SERVICE BULLETIN

APPLICABILITY: 2013MY Impreza 2.0L NA Models
 2013MY XV Crosstrek™

NUMBER: 11-127-13R

SUBJECT: ECM Reprogramming Availability for DTCs
 P0017 & P0019

Intake Flow Chart

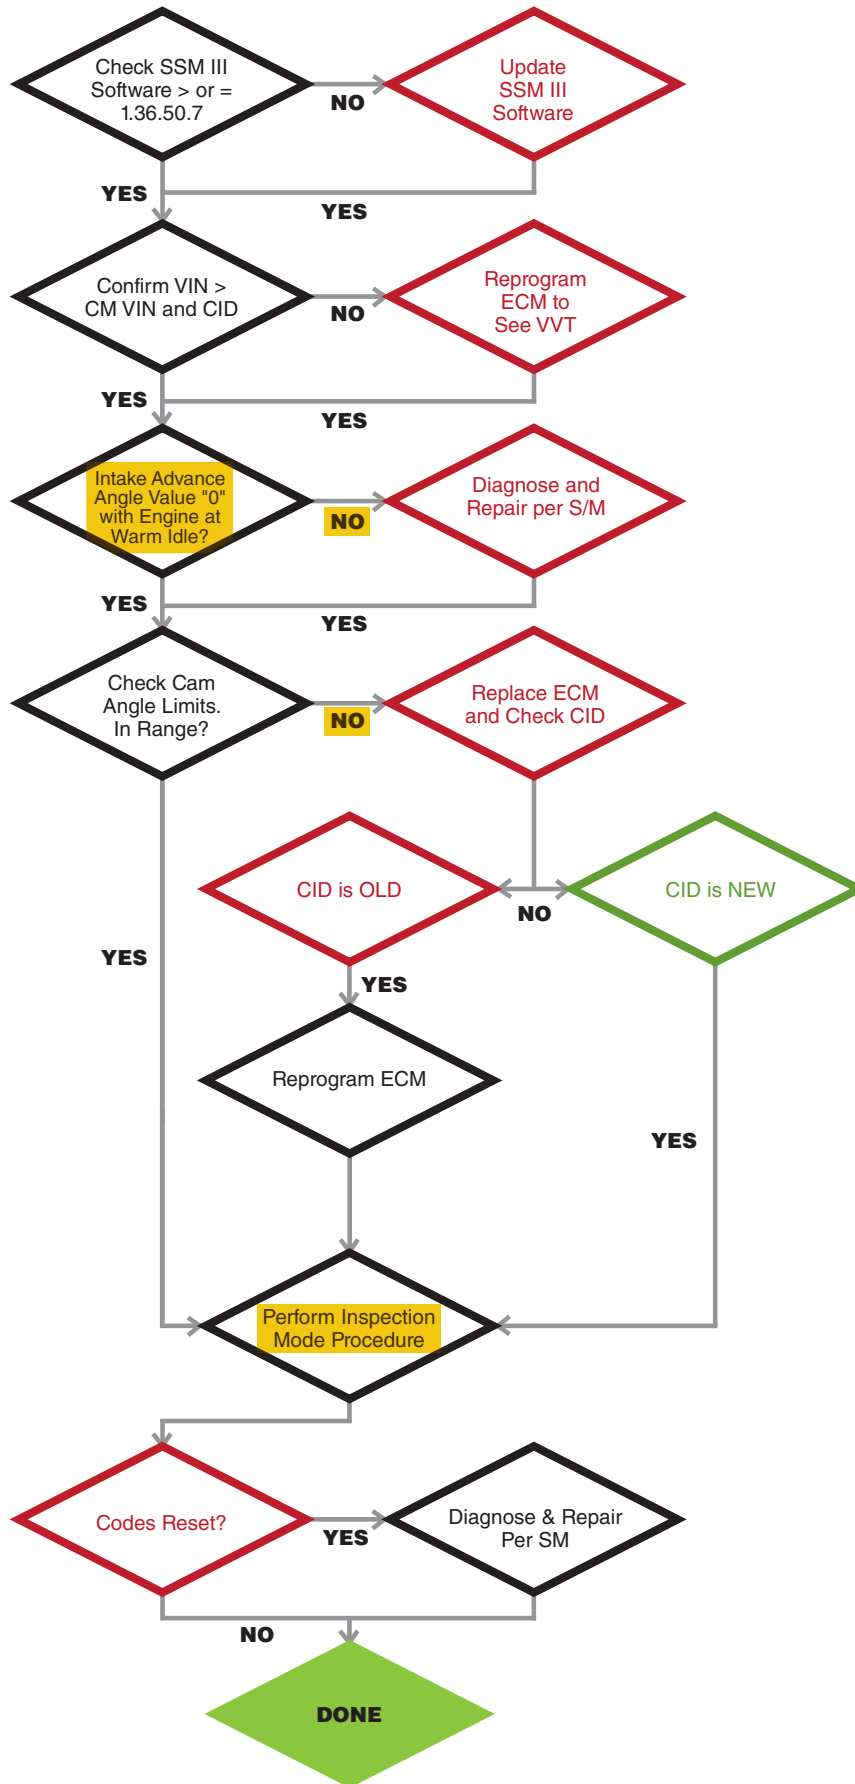
For the **INTAKE**, the chart above shows values within the Specified Limits (number crankshaft angle degrees) which are a **MINIMUM of 50** and a **MAXIMUM of 70**. Check the SSMIII data for VVT Advance Angle Amount as shown below.

With the engine at idle and at operating temperature, this value must be “0”. If confirmed to be “0”, proceed with the remaining steps on the INTAKE Flow Chart. If not “0”, diagnose and repair the VVT system per the Service Manual.

Exhaust Flow Chart

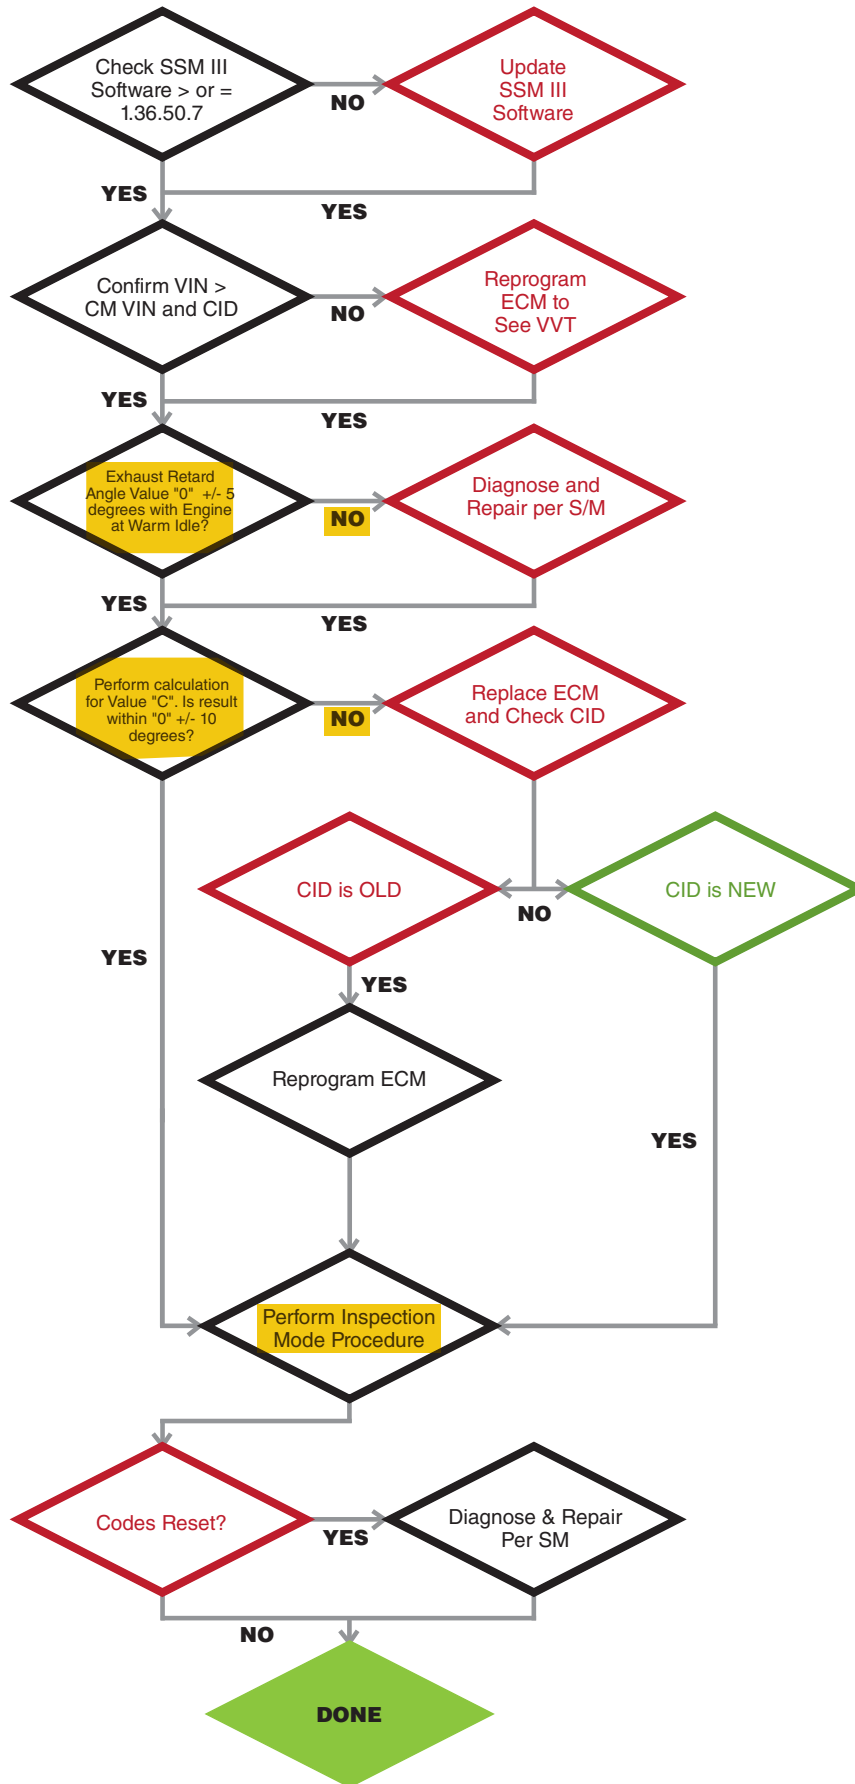
For the **EXHAUST**, the formula shown below must be used to determine if an ECM replacement is needed. Check the SSMIII data for Exhaust VVT Retard Angle as shown below. The specified range for this value is “0” +/- 10 degrees.

- **A=** Exhaust VVT Retard Angle Value, read with the engine at idle and at operating temperature (This value may be a positive or negative number.)
- **B=** VVT Exhaust Initial Position Learning Value
- **Formula: C = A + B - 90** (The 90 value in the formula represents the midpoint of the Specified Limit range.)

Does the value of C = “0” +/- 10 (degrees)?

1. **Yes-** Perform Inspection Mode and if no DTCs reset, the car is repaired.
2. **No-** Replace the ECM then follow the remaining steps on the Flow Chart.
